COMMUNITY BOARD FEEDBACK PACKAGE

DINING OUT NYC COMMUNITY BOARD RECOMMENDATION FORM

Business Name: Glur

Cafe Address: 144 West 19th Street, New York, NY, 10011

REVISED SITE PLANS

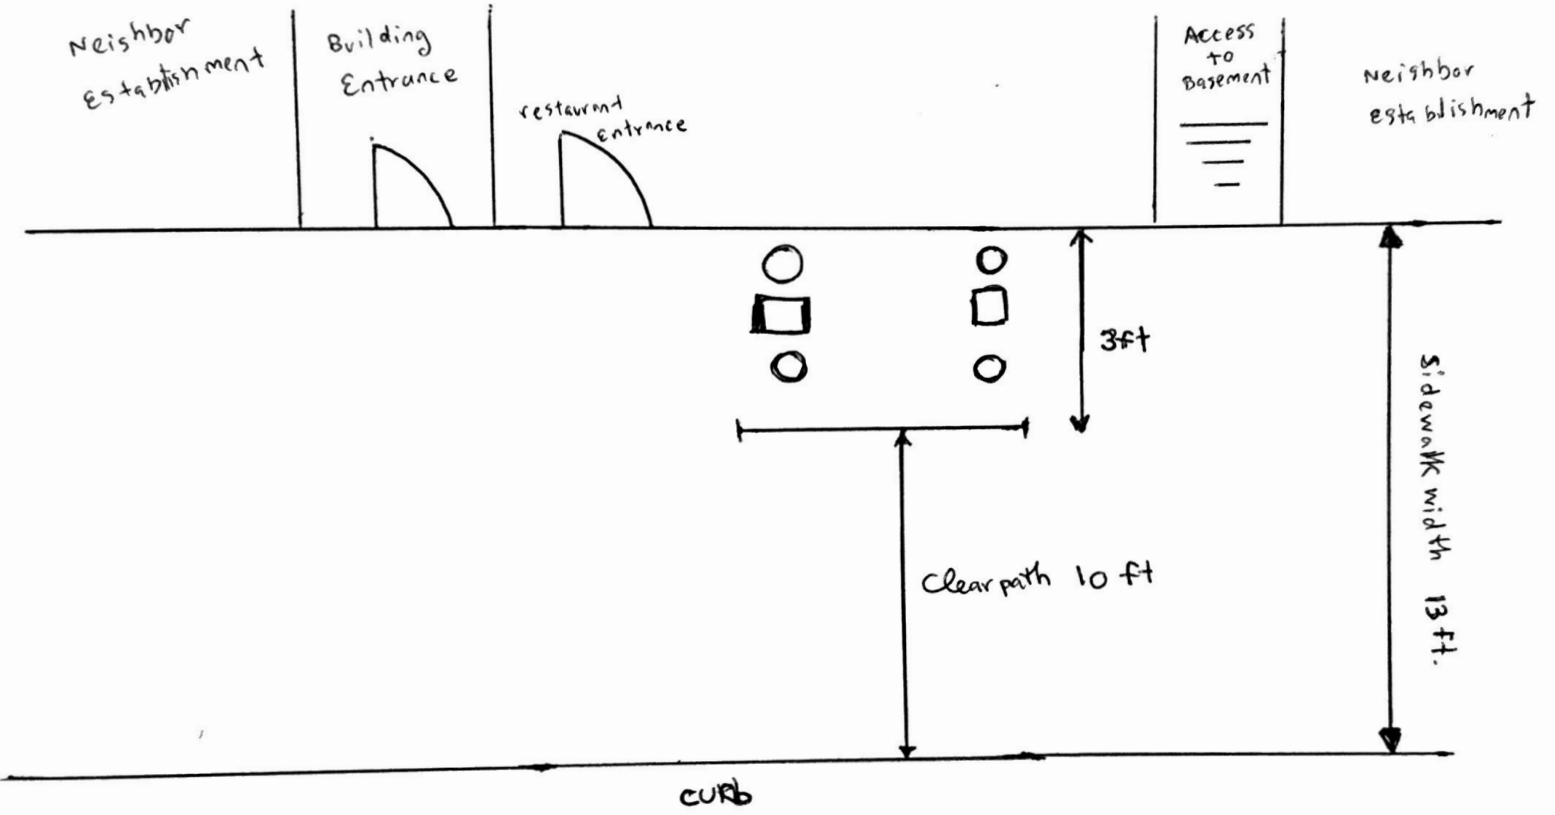
The 3 tables/6 seats reflected on the original site plan could not fit in front of applicant's premises as is required.

To limit the sidewalk cafe to the front of applicant's premises as is required, MCB4 requests that the sidewalk cafe be reduced to 2 tables no larger than 14"x14" with 2 chairs at each table. The applicant has agreed to this change and prepared the attached Revised Site Plan reflecting this change. Applicant also has agreed with MCB4 that, per the Revised Site Plan, the sidewalk cafe and all service to it must be confined to the 3-foot strip along the building facade.
